Ref: Request for additional information regarding the renewal application for NRC License No. 13-32212-01

March 23, 2020

### I-131 Fume Hood

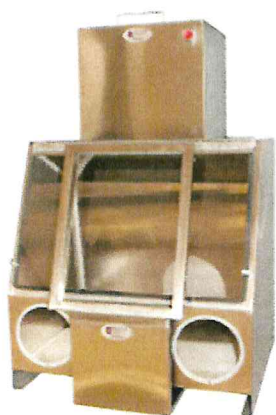
- 4) **You request to possess and use many radionuclides in any physical and chemical form. Where radioactive materials may become airborne, please provide schematic descriptions of the ventilation systems with pertinent airflow rates, pressures, filtration equipment, and monitoring systems.**

We confirm that volatile radionuclides Iodine-125, Iodine-131 and Astatine-211 will be used in an iodination fume hood equipped with an activated charcoal filter to trap radioactive materials. The hood will be tested and approved prior to use. Bioassay will be performed after the use of volatile radionuclides to ensure that exposures remain ALARA.

- Used during the preparation of I-131 and other radiopharmaceuticals
- Designed to be used with an L-Block shield that slides under the front of the Fume Hood (L-Block not included)
- Constructed of stainless steel and rugged polycarbonate
- Provides a spacious work area with ample arm ports that allow easy access to the work area
- Hinged front door allows easy placement and retrieval of items
- Fan and air baffle assure even flow of air out of the hood
- Fan motor is 120 VAC, 60 Hz
- Two 12" x 12" x 1" disposable charcoal filters included
- Draws 135 CFM
